SUMMARY REPORT 2
REVIEW OF FLOOD INSURANCE STUDY
TOWN OF FORT MYERS BEACH, FLORIDA

Submitted to
Town of Fort Myers Beach, Florida
2523 Estero Boulevard
Fort Myers Beach, Florida

Submitted By
Tomasello Consulting Engineers, Inc.
5906 Center Street,
Jupiter, Florida 33458

March 2006

Figure 8

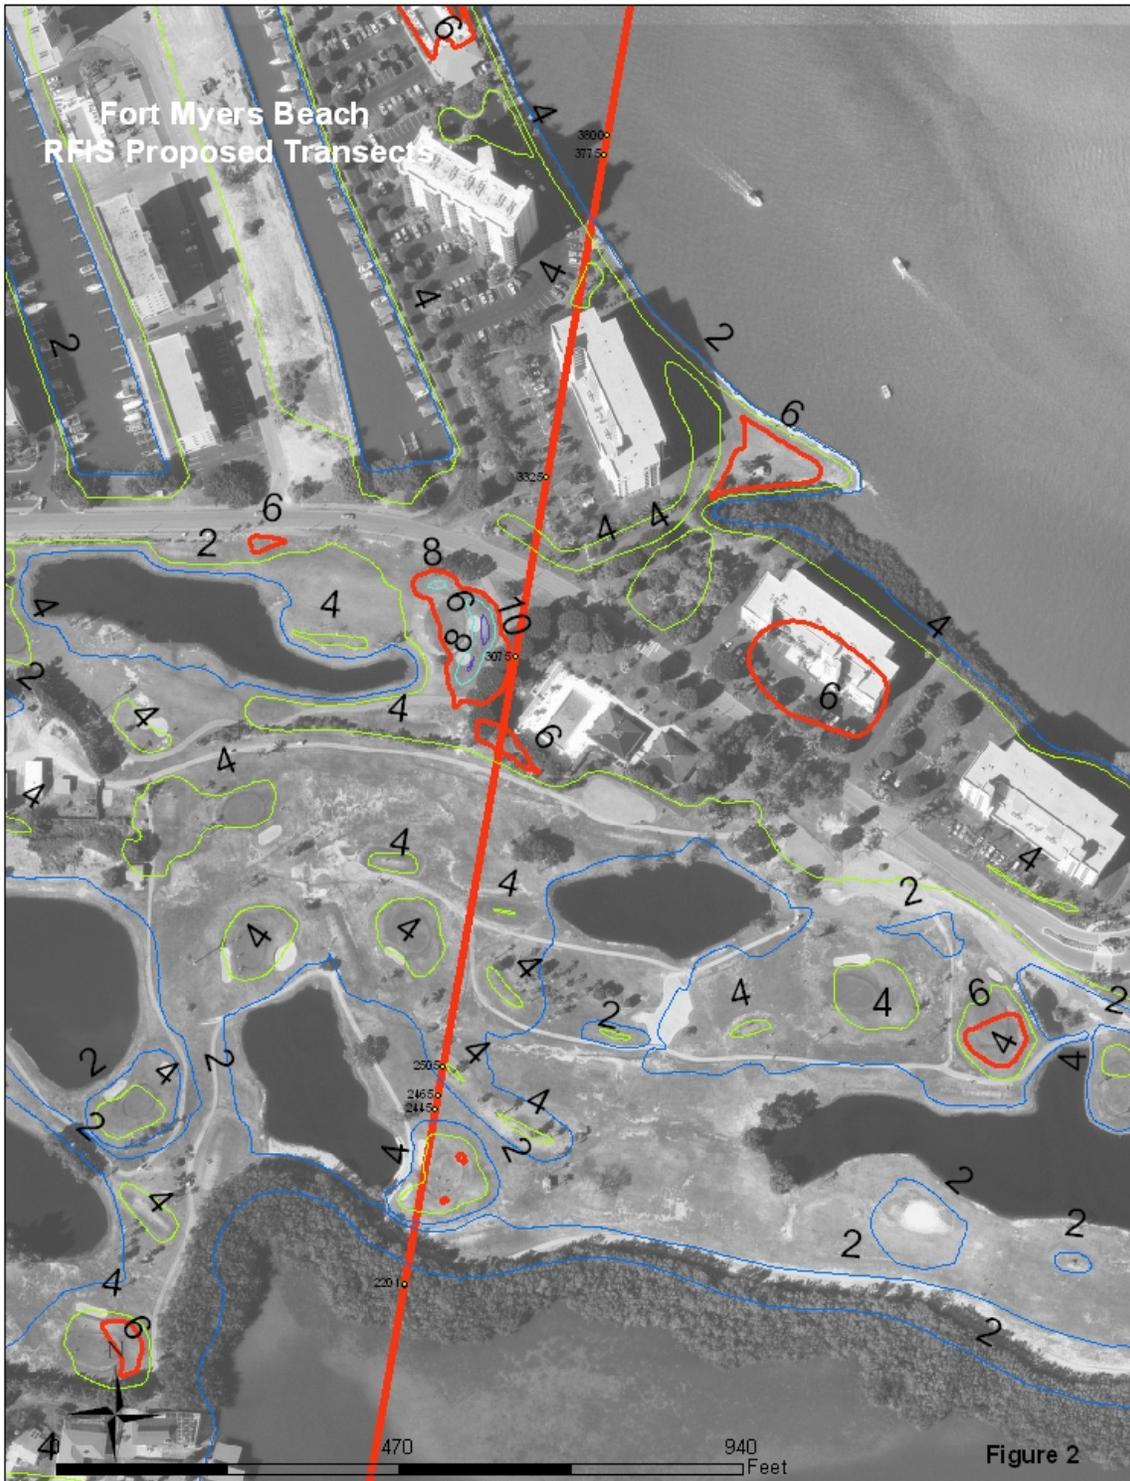
For Transect 16, TCE again followed much of the same approach as used in Transect 13. The FEMA contractor applied a DU (dune) card along Transect 16 from 726' to 815'. TCE applied a building card to represent the transect segment from 680' to 815'. TCE used the 20% of building width method as described in Transect 13 for the first row of buildings in Transect 16. At the distance of 1575', TCE changed the 10% still water to 9.32' NAVD to represent the SFWMD still water flood elevation on the Estero Bay side of the barrier island. The FEMA contractor used 11.22' NAVD, the SFWMD still water computed for the open coast.

The aerial photo with location of Transect 16 and FEMA's contractors' distances can be found on Figures 8 and 9. Comparisons of CHAMP WHAFIS cards for Transect 16 can be found on Figure 10. TCE CHAMP model runs (inputs and outputs) for Transect 16 can be found in Appendix B on CD

Figure 12

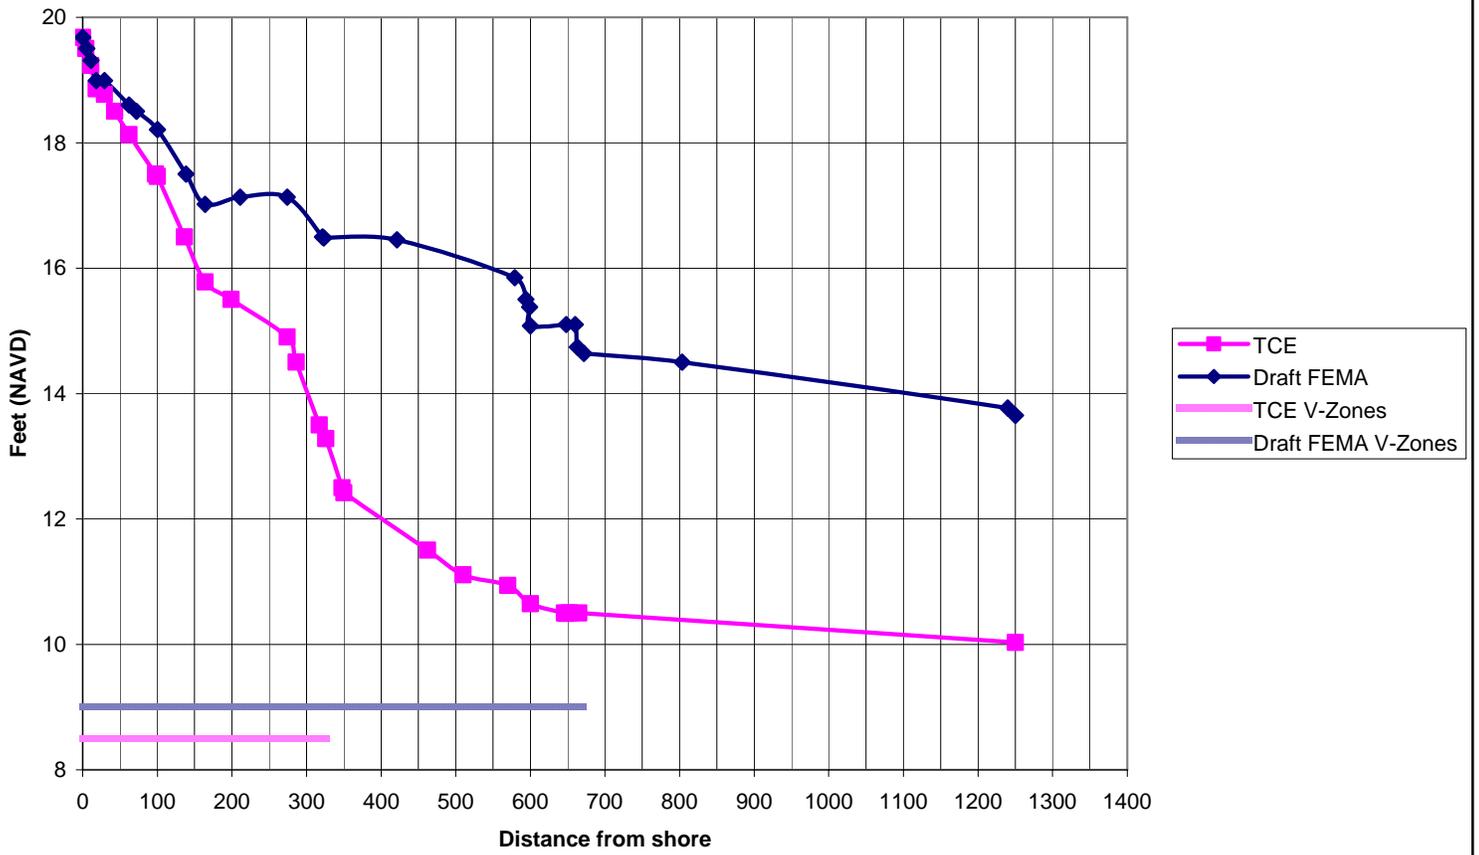
With changes made in WHAFIS cards and still water inputs, the location of the V zone at Transect 13 was moved a distance of 345' westerly toward the Gulf of Mexico. FEMA contractor's CHAMP Part 5 – Location of V zones was 671' from the 0.0' point ¹, while TCE's CHAMP Part 5 – Location of V zones was 326' from the 0.0' point (See Appendix B). Comparisons of CHAMP Part 6 – Numbered A Zones and V zones and Part 5- Location of V zones for Transect 13 can be found on Figure 11. Chart of comparisons of Parts 5 and Part 6 for Transect 13 can be found on Figure 12. For Transect 13, the differences in the inland extent of the v-zones and flood elevations computed by TCE versus FEMA contractor are displayed on Figure 12.

TCE identified inconsistencies in the FEMA contractors' inputs to the CHAMP WHAFIS analyses. In the TCE revised transects corrections to the input still water flood elevations to reflect the SFWMD computed still water levels on the Estero Bay side of the barrier island were applied consistent with FEMA methodology. TCE revised CHAMP WHAFIS card inputs were also applied along the transects consistent with FEMA methodologies. The resulting wave effected flood elevations and V-zone location were plotted on Figures 12, 14, 16 and 18.

Figure 14

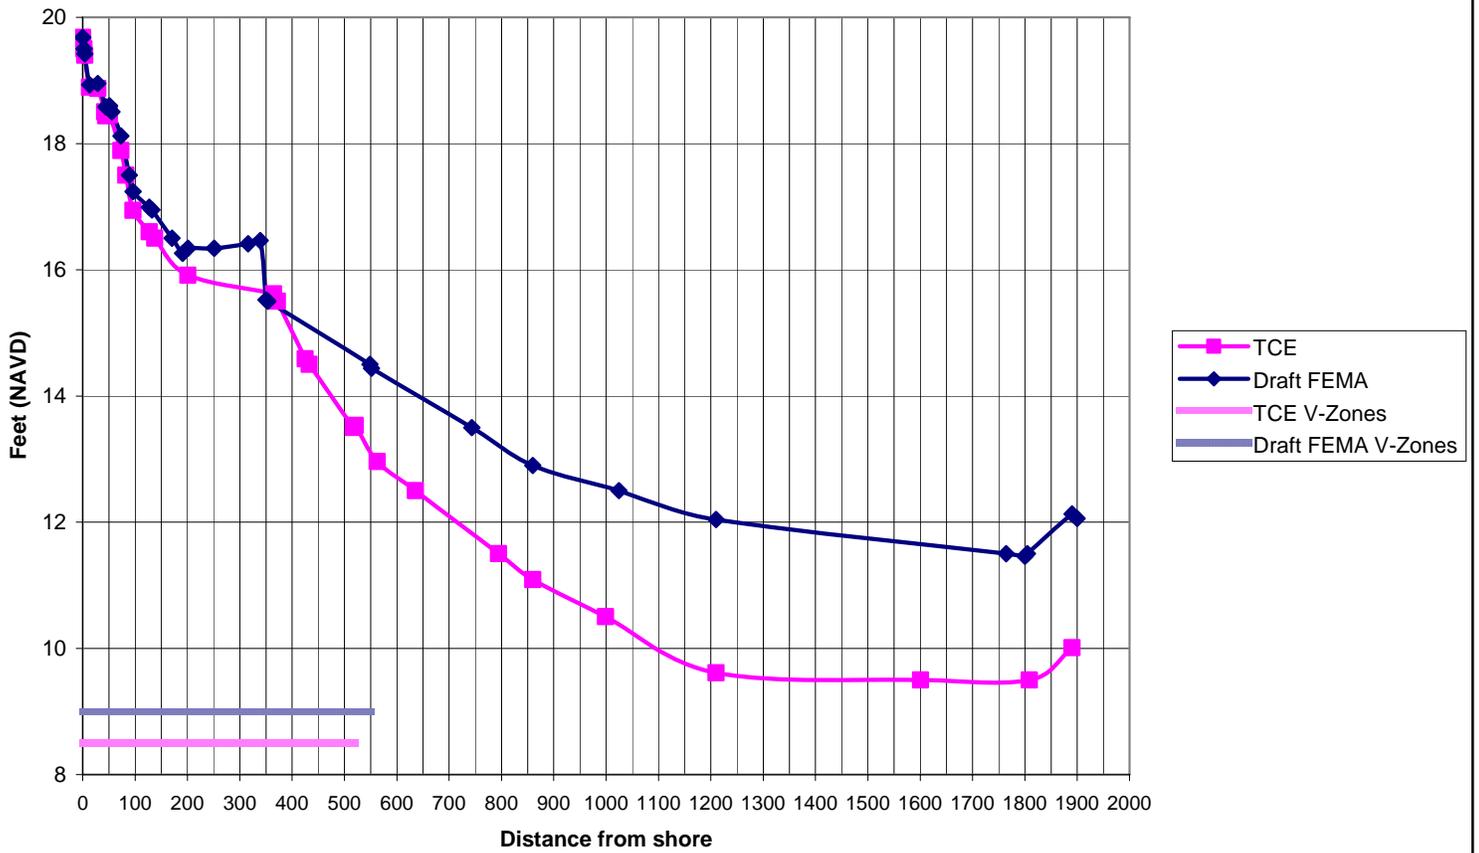
With changes made in WHAFIS cards and still water inputs, the location of the V zone at Transect 14 was moved a distance of 31' westerly toward the Gulf of Mexico. FEMA contractor's CHAMP Part 5 – Location of V zones was 551' from the 0.0' point ¹, while TCE's CHAMP Part 5 – Location of V zones was 520' from the 0.0' point (See Appendix B). Comparisons of CHAMP Part 6 – Numbered A Zones and V zones and Part 5- Location of V zones for Transect 14 can be found on Figure 13. Chart of comparisons of Parts 5 and Part 6 for Transect 14 can be found on Figure 14. For Transect 14, the differences in the inland extent of the v-zones and flood elevations computed by TCE versus FEMA contractor are displayed on Figure 14.

Figure 16

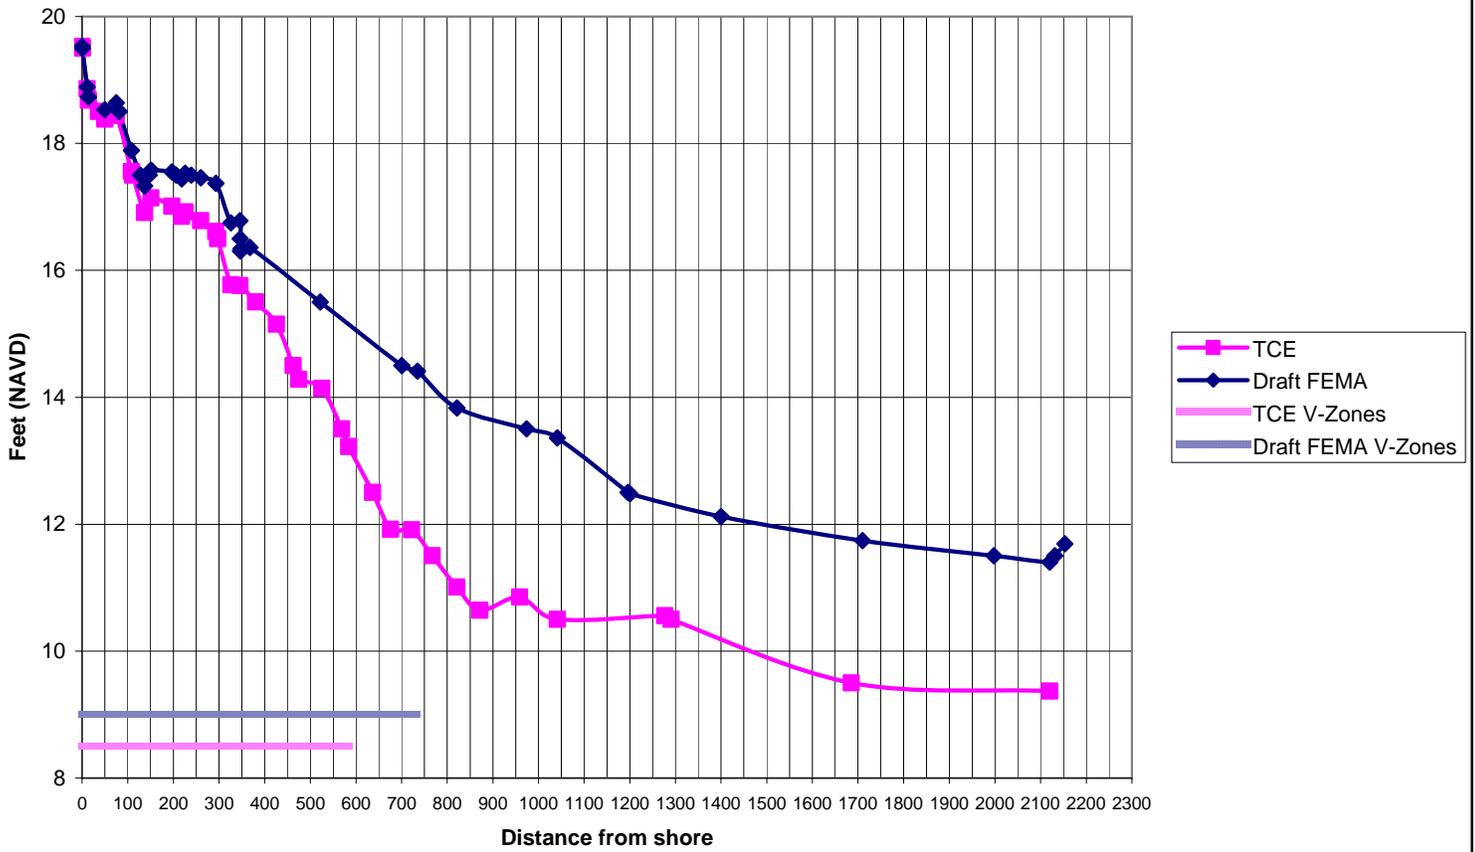
With changes made in WHAFIS cards and still water inputs, the location of the V zone at Transect 15 was moved a distance of 149' westerly toward the Gulf of Mexico. FEMA contractor's CHAMP Part 5 – Location of V zones was 734' from the 0.0' point ¹, while TCE's CHAMP Part 5 – Location of V zones was 585' from the 0.0' point (See Appendix B). Comparisons of CHAMP Part 6 – Numbered A Zones and V zones and Part 5- Location of V zones for Transect 15 can be found on Figure 15. Chart of comparisons of Parts 5 and Part 6 for Transect 15 can be found on Figure 16. For Transect 15, the differences in the inland extent of the v-zones and flood elevations computed by TCE versus FEMA contractor are displayed on Figure 16.

Figure 18

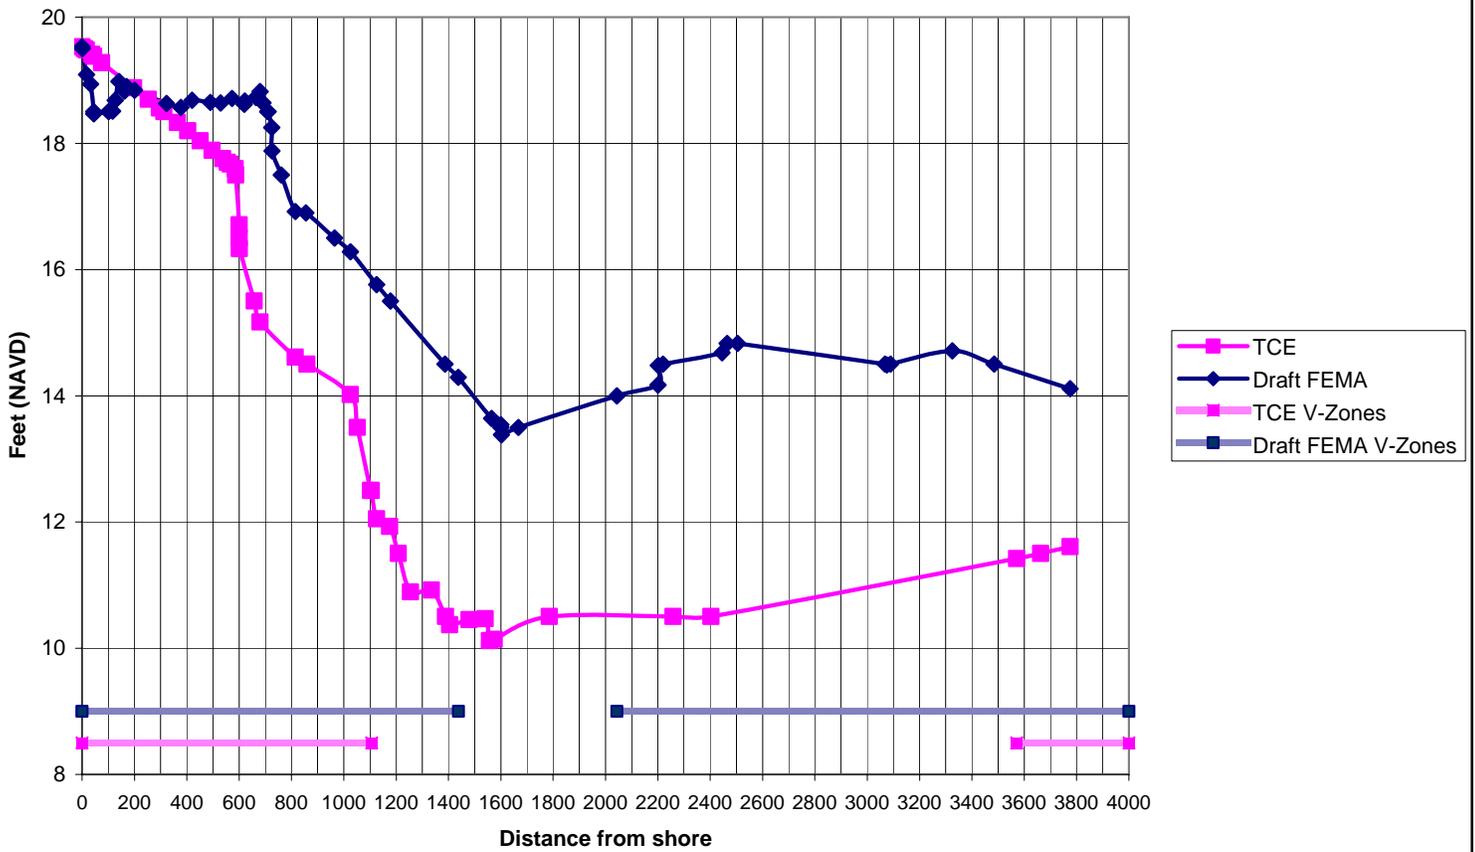
With changes made in WHAFIS cards and still water inputs, the location of the V zone at Transect 16 was moved a distance of 332' westerly toward the Gulf of Mexico. FEMA contractor's CHAMP Part 5 – Location of V zones was 1438' from the 0.0' point ¹, while TCE's CHAMP Part 5 – Location of V zones was 1106' from the 0.0' point (See Appendix B). Comparisons of CHAMP Part 6 – Numbered A Zones and V zones and Part 5- Location of V

zones for Transect 16 can be found on Figure 17. Chart of comparisons of Parts 5 and Part 6 for Transect 16 can be found on Figure 18. For Transect 16, the differences in the inland extent of the v-zones and flood elevations computed by TCE verses FEMA contractor are displayed on Figure 18.
